Town of Wallingford, Connecticut

FINAL AGENDA

VN Engineers, Inc. (VNE) is pleased to provide this peer review of the traffic impact study and site plans for the proposed Delivery Station Building at 5 Research Parkway in Wallingford, Connecticut. The 179.85-acre project site, which was previously occupied by Bristol Myers Squibb, is located within the Industrial Expansion (IX) zone and Wallingford Watershed Protection District (WPD). The site is presently unoccupied. The project includes the construction of a 219,000± square-foot warehouse building with 1,508 parking spaces.

Estimation of Net Vehicles on Site: Average Weekday

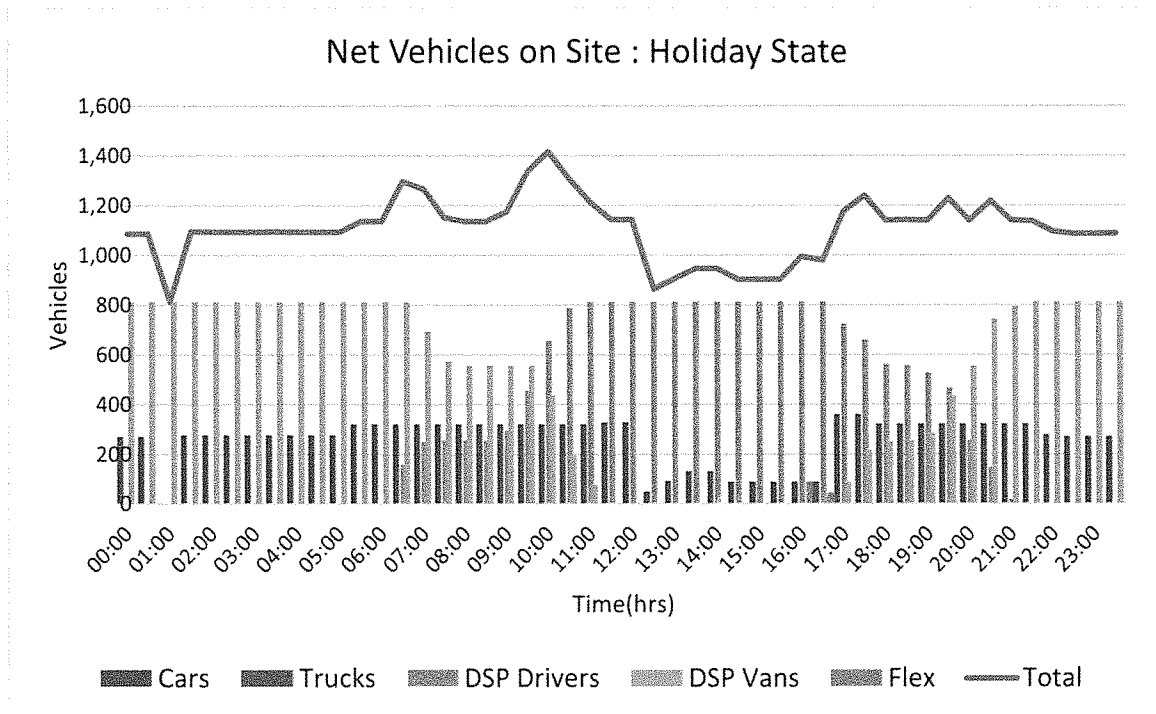
20. The traffic report should address how much the trip generation is expected to increase during the holiday season peak. Additional analysis should be provided to demonstrate how traffic operations will be impacted during this peak season.

Response: The additional parking is required for anticipated peak holiday traffic at the Site. 24-hour traffic generation charts have been added to the appendix of the report. Additional analysis for the Holiday Peak is also provided in the Appendix of the report. Charts showing the number of vehicles on Site at any time over a 24-hour period during steady state and Holiday period have been attached to this response to comments.

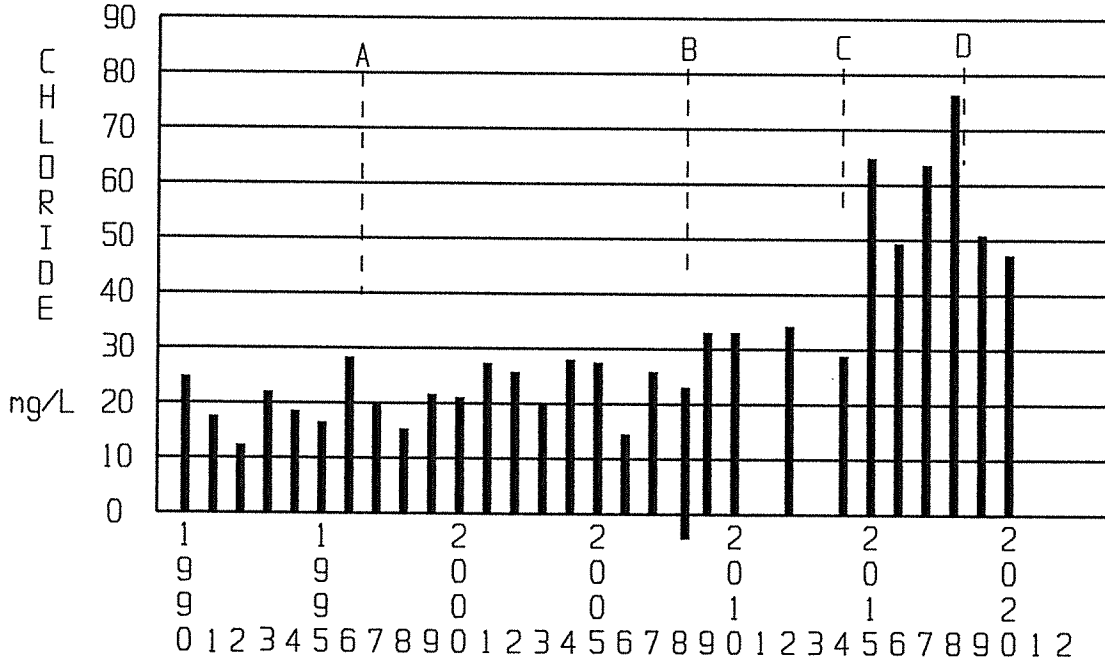
Levels before BMS would be helpful to support this. They might lower the base line.

- Levels in my well, 30 feet from the Muddy River, show the same trend with much higher levels.

Sample levels along the Muddy River would be different if taken above or below Spring Brook

MUDDY RIVER CHLORIDE (Cl) IN RAW WATER SOURCES

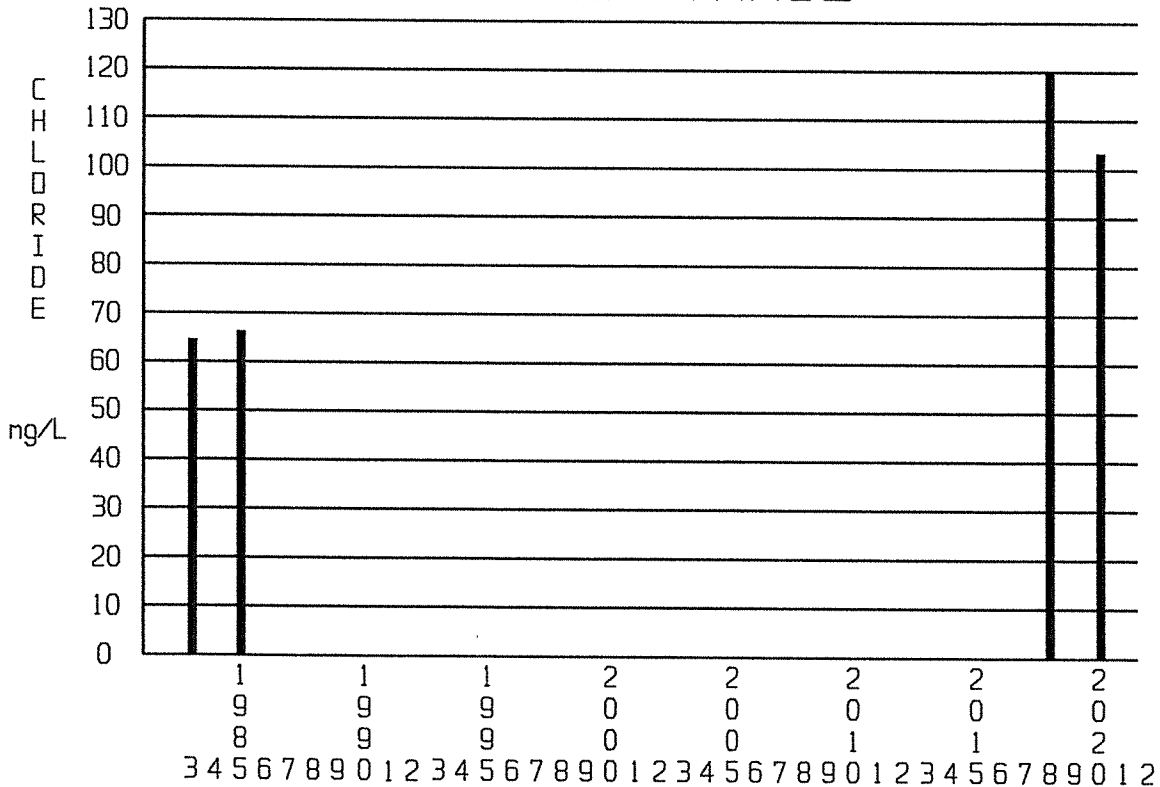
- I believe the Wallingford Water Department is very concerned that the chlorides have doubled in such a short time. I hope they can add to this topic.
